HOT CHANNEL FACTOR
NORMALIZED OPERATING ENVELOPE

SUBJECT: Docket Nos. 50-250 and 50-251, Turkey Point Plant, Units
No. 3 and 4

Figure 3.2-3

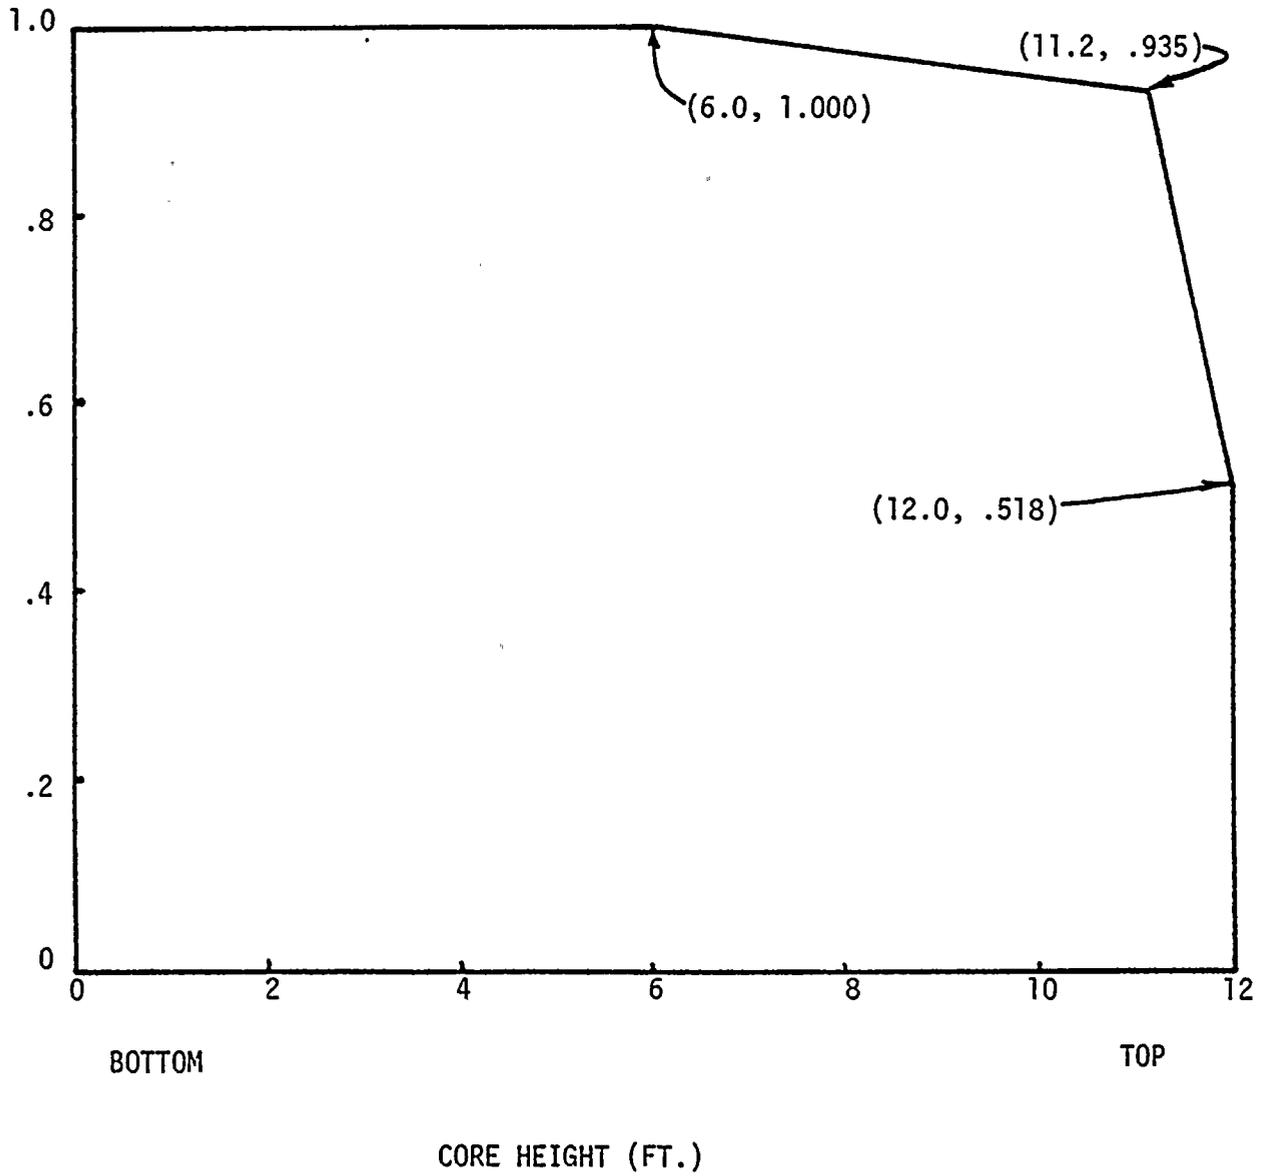
Where P is the fraction of rated power at which the core is operating; K(Z) is the function given in Figure 3.2-3, Z is the core height location of F_Q . $[F_Q]_L$ and K(Z) are dependent on the steam generator tube plugging level as follows:

Plugging level	$[F_Q]_L$	Figure Number for K(Z)
$\leq 25\%$	1.93	3.2-3

An upper bound envelope as defined by normalized peaking factor axial dependence of Figure 3.2-3, has been determined to be consistent with the technical specifications on power distribution control as given in Section 3.2.
